**BOULDER COUNTY  
PLANNING COMMISSION  
PUBLIC HEARING**

## STAFF RECOMMENDATION

### Docket SU-20-0005: Hillside School Modification

**Proposal:** Modification to an existing Special Review and Site Specific Development Plan (SU-03-09) to approve the phased construction of a new school building and reconstruction of an existing school building, for a total floor area of 14,284 square feet, containing 13 total classrooms for up to 136 students (68 during a morning session, and 68 during an afternoon session).

ISSUE	DATE
CONCEPT REVIEW	09/21/2020
DESIGNED BY:	CCS
DRAWN BY:	TSG
CHECKED BY:	
DRAWING SCALE: HORIZONTAL: 1" = 20' VERTICAL: NONE	
EXISTING CONDITIONS DRAINAGE	
PROJECT NO. B1335	
<b>DR1</b>	
SHEET: 1 OF 2

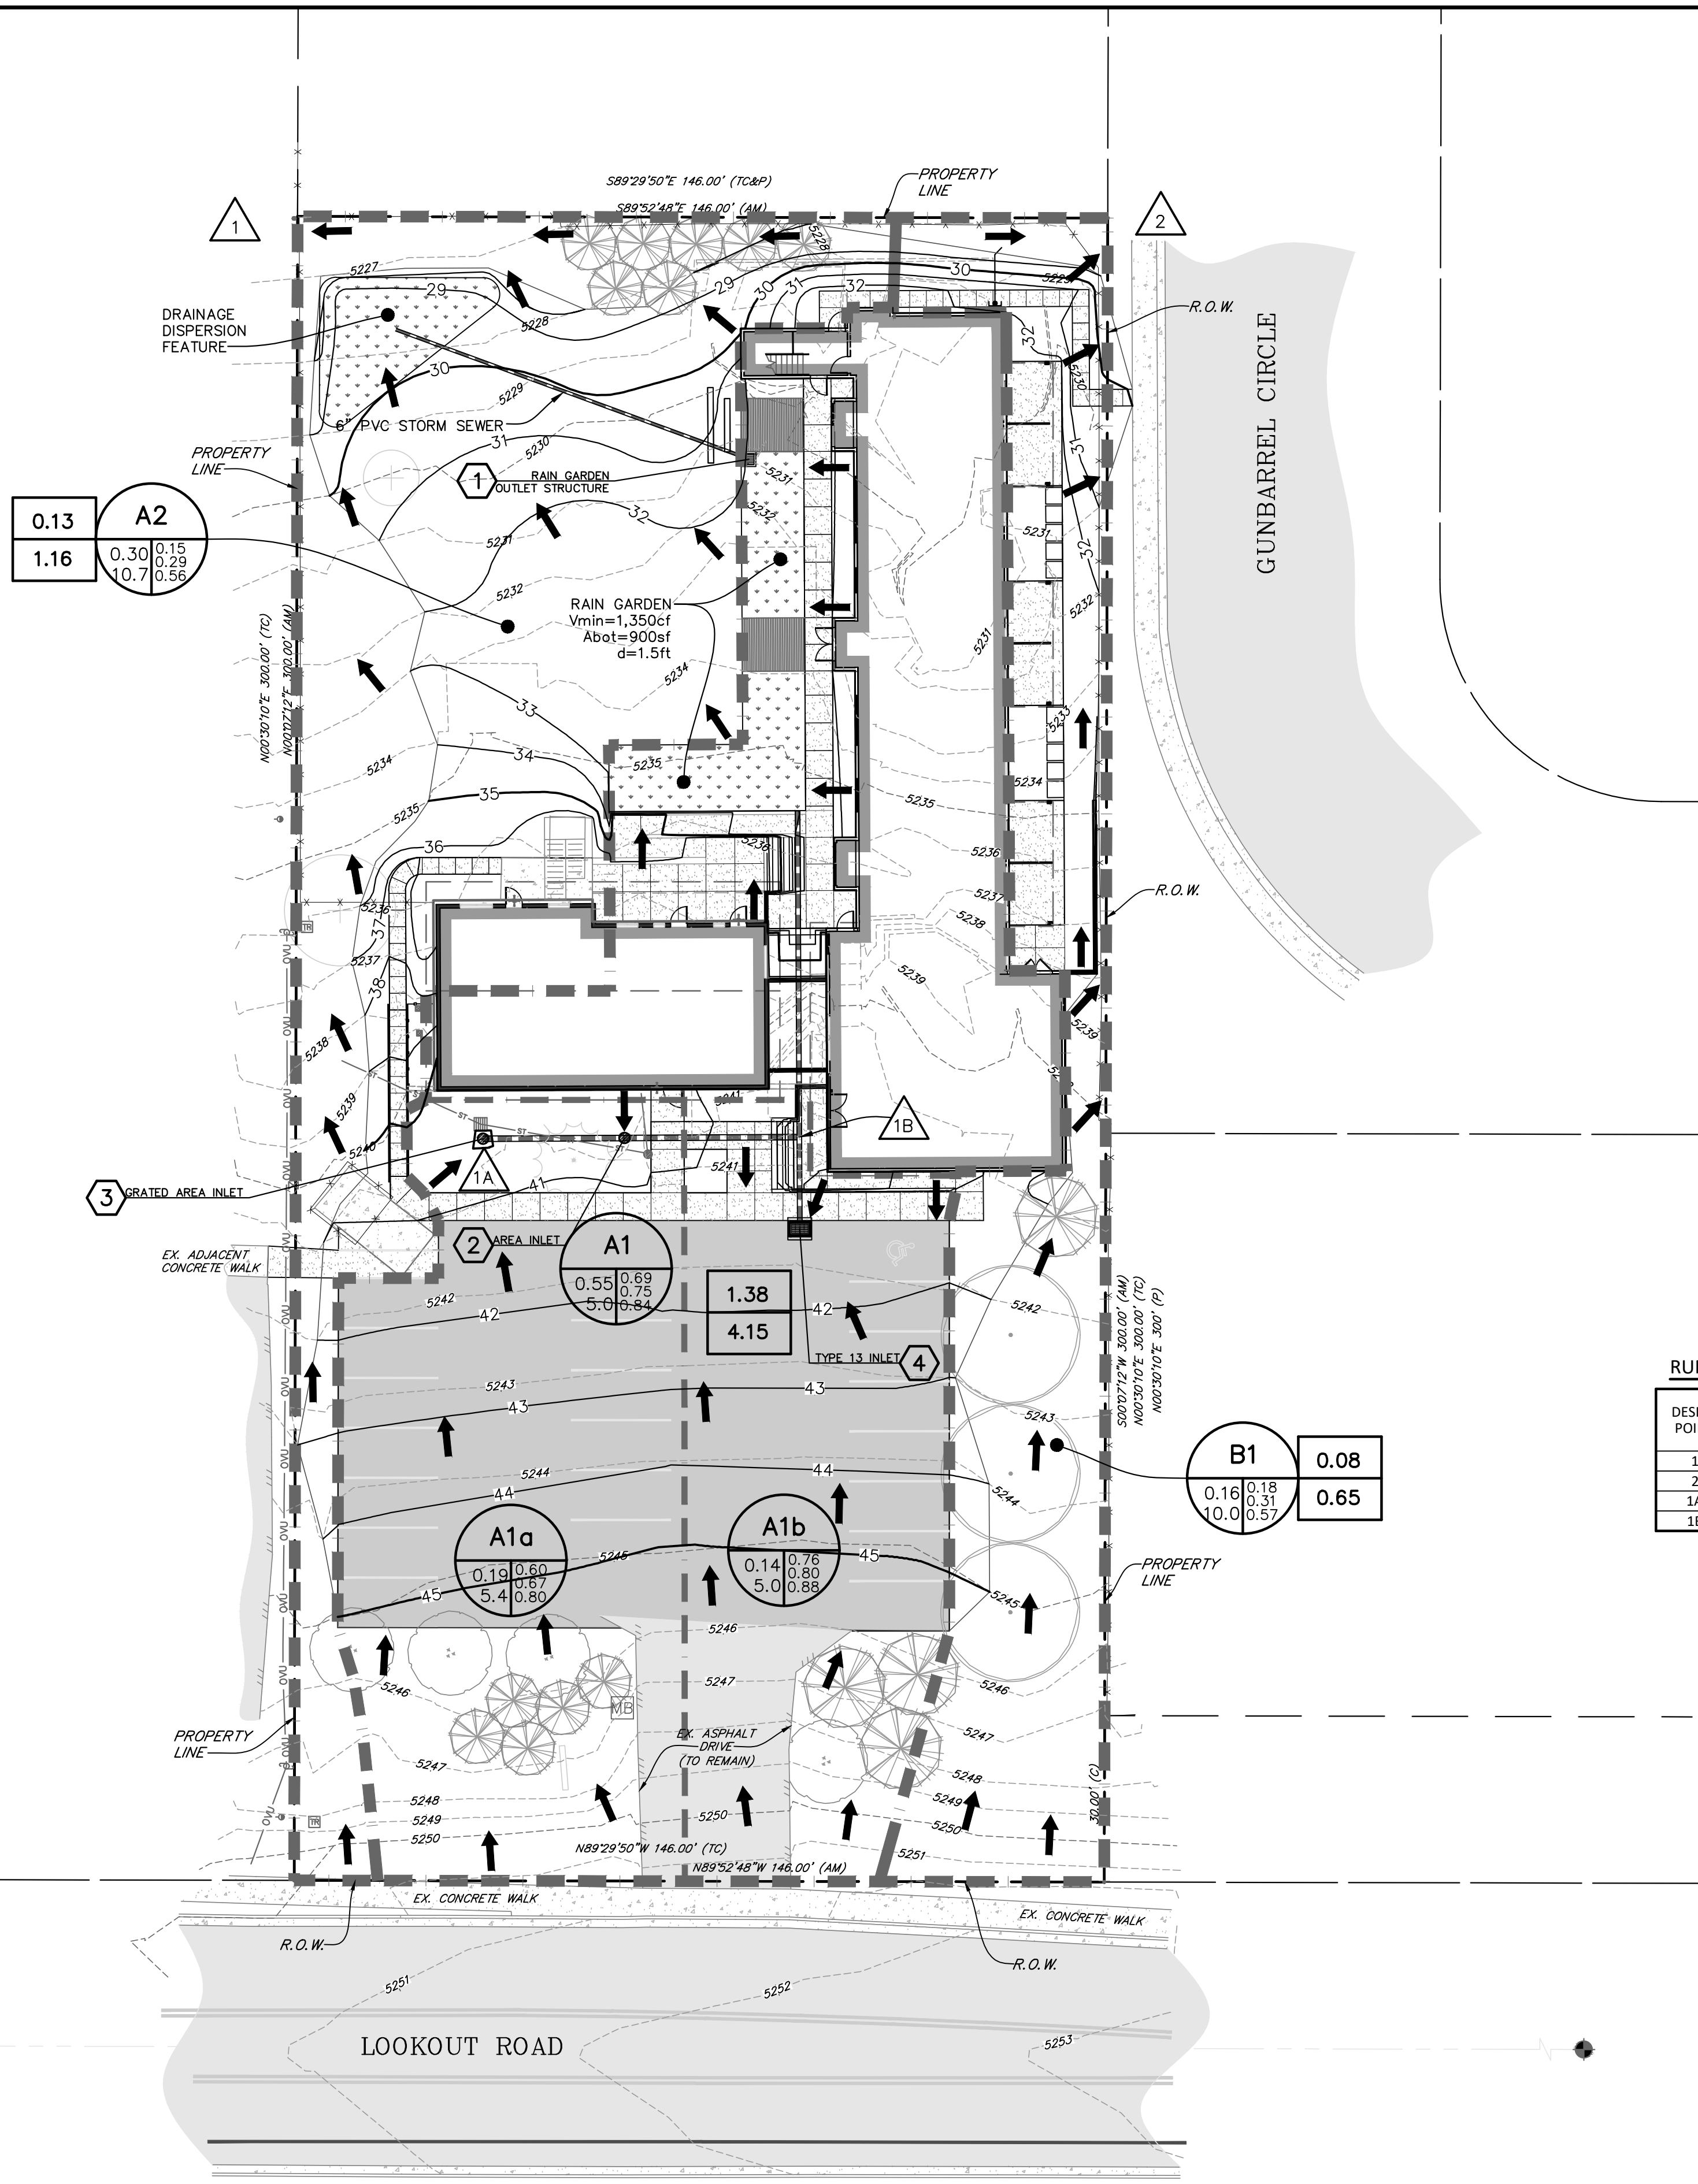
7. The revised Drainage Study includes hydraulic analysis for 8-inch and 10-inch PVC pipes in Appendix C; however, sheet plan sheet C1.O Drainage Plan in the application materials identifies 8-inch and 6-inch pipes and the sheet notes mention the use of 4-inch perforated pipes. A grading and drainage plan, that provides consistent hydraulic details must be submitted and approved as a part of the building permit application. The plan must be signed and stamped by a Colorado registered Professional Engineer, Landscape Architect, or Architect.

16. *At building permit submittal*, a revised drainage study must be included with the application materials that provides for consistent hydraulic details. The plan must be signed and stamped by a Colorado registered Professional Engineer, Landscape Architect, or Architect.
  - a. The drainage study includes hydraulic analysis for 8-inch and 10-inch PVC pipes in Appendix C; however, plan sheet C1.O Drainage Plan in the application materials identifies 8-inch and 6-inch pipes, and the sheet notes mention the use of 4-inch perforated pipes. These issues must be rectified on the revised plan.
17. The applicants shall be subject to the terms, conditions, and commitments of record and in the file for docket SU-20-0005 Hillside School Modification.

**1 NORTH ELEVATION**  
1/8" = 1'-0"

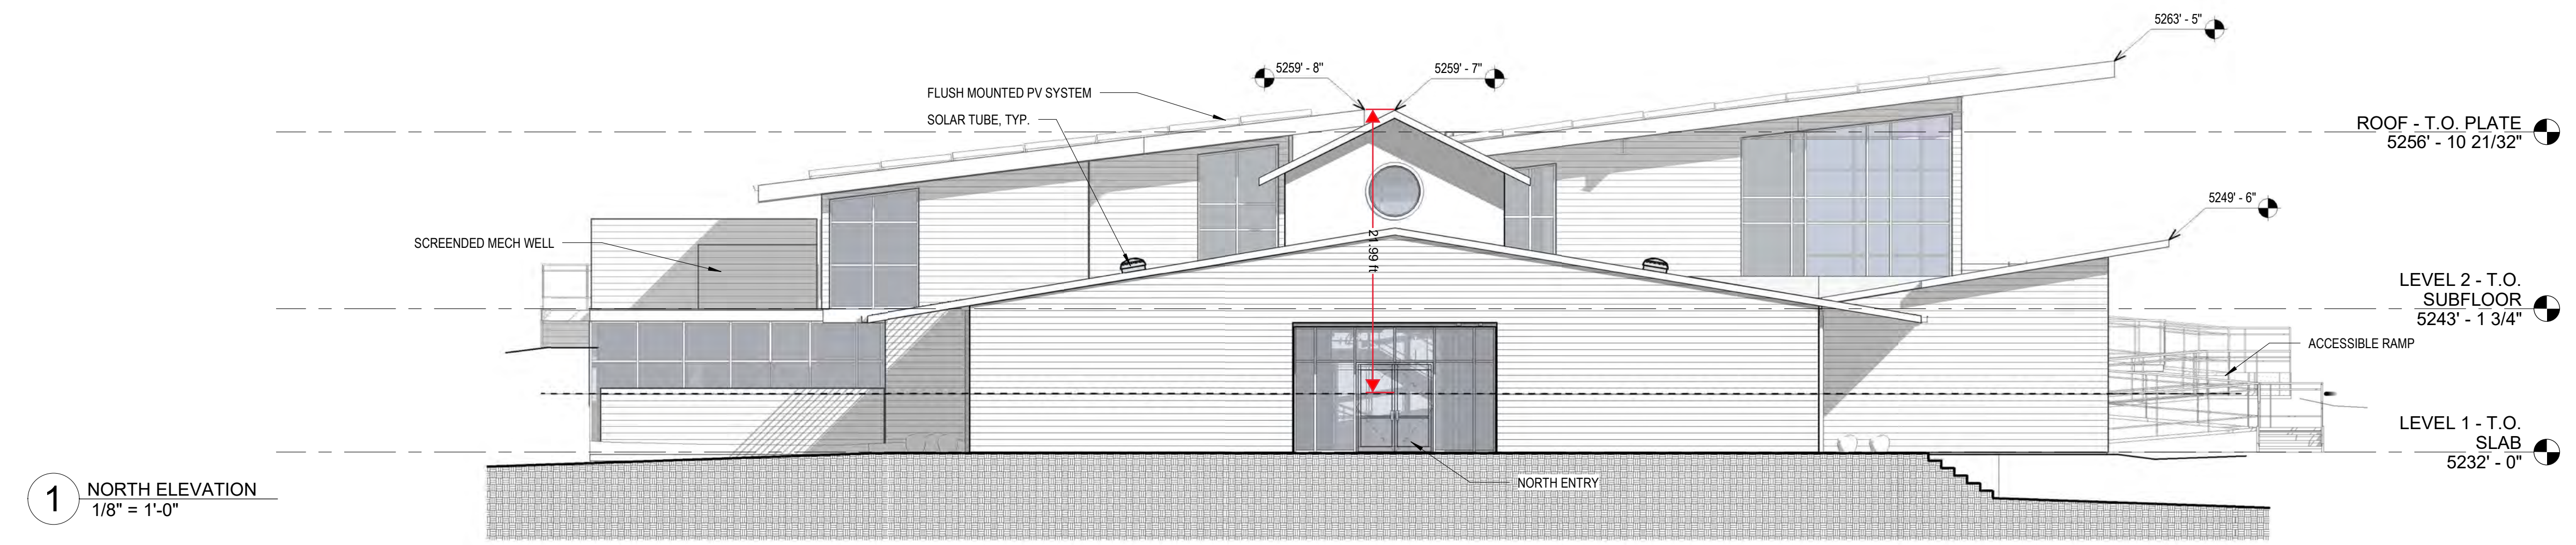
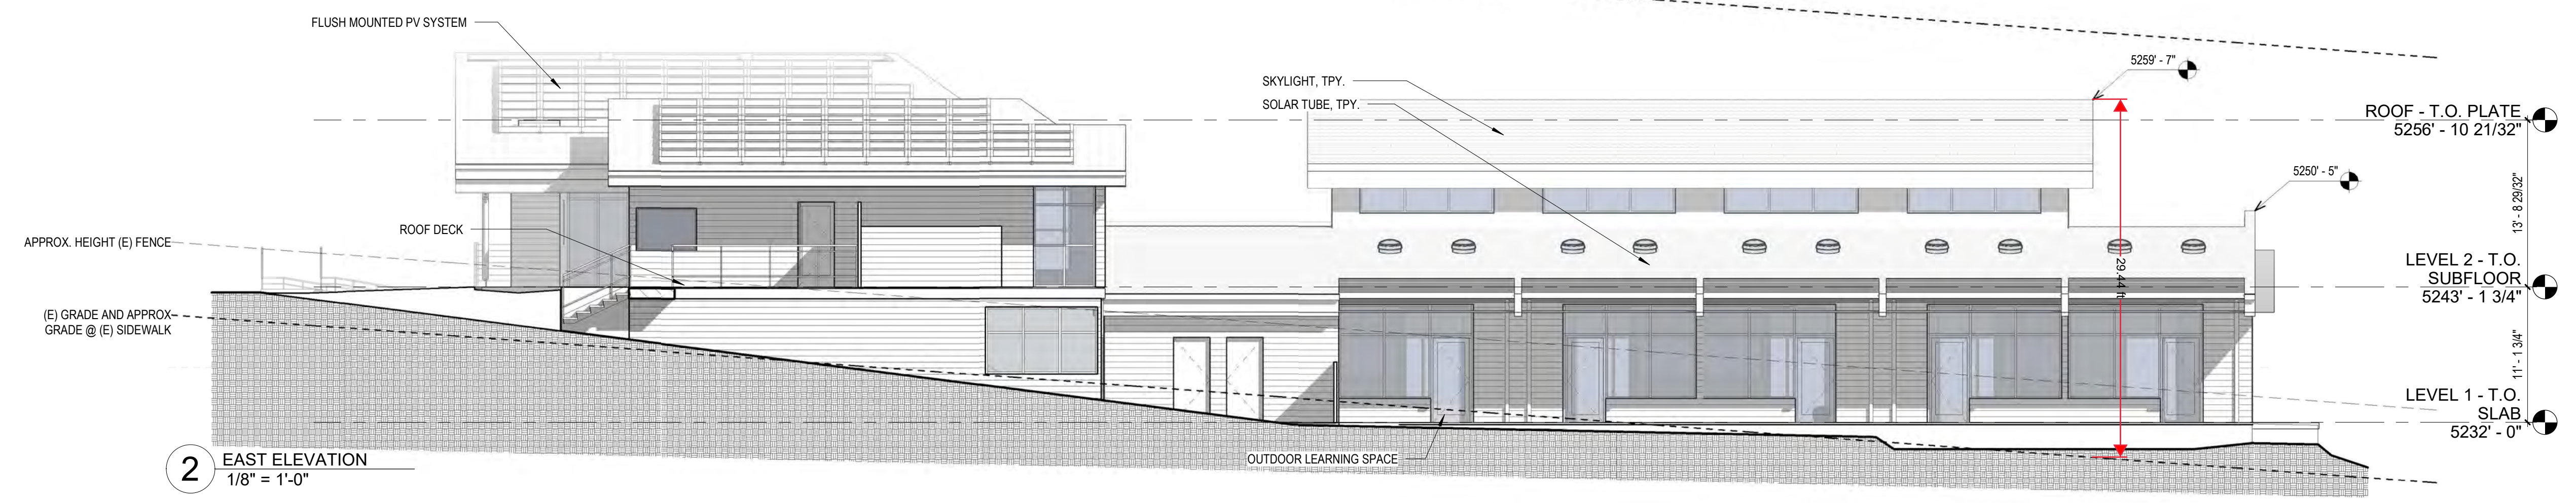
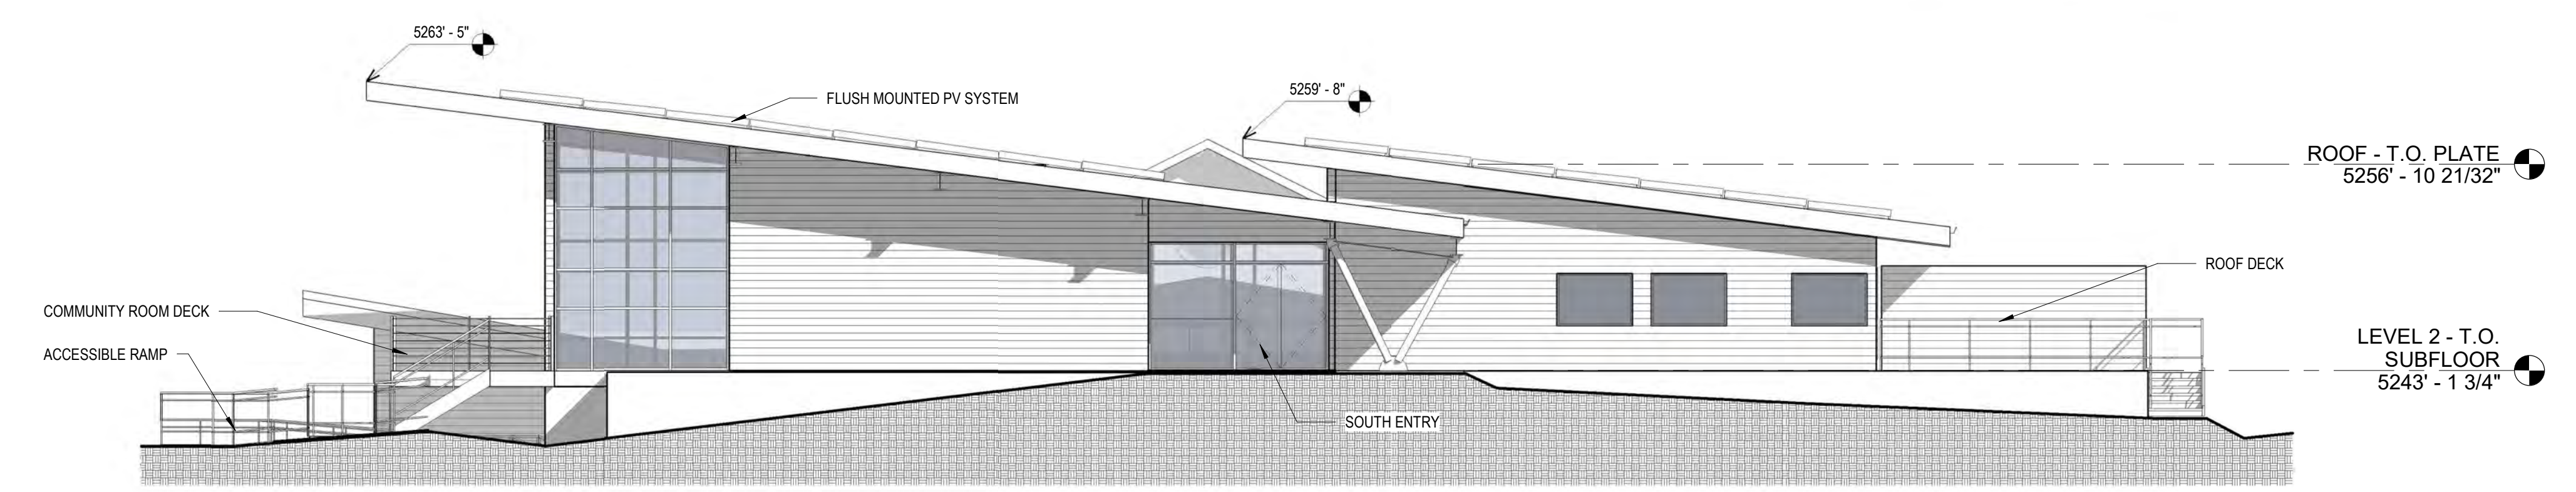
The proposed maximum height of construction is approximately 29' 5" above existing grade, as shown on the revised elevations submitted to staff on Thursday, March 3, 2022 and included as part of Attachment D. Although the proposed maximum height is nearly 30 feet, this area of maximum height is located at the northern end of the property at the lowest elevation of currently existing grade. For parcels on subdivided land with a final plat approved by the County prior to August 29, 1994 and located within the Suburban Residential zoning district (as applies to the subject parcel), the maximum building height is 35 feet above existing grade. In order to ensure that the visual impact to the nearby neighbors is reduced as much as possible, while allowing for small amounts of variance in the permitting process, staff recommend a condition of approval limiting the height of all portions of both structures to 30 feet above existing grade.
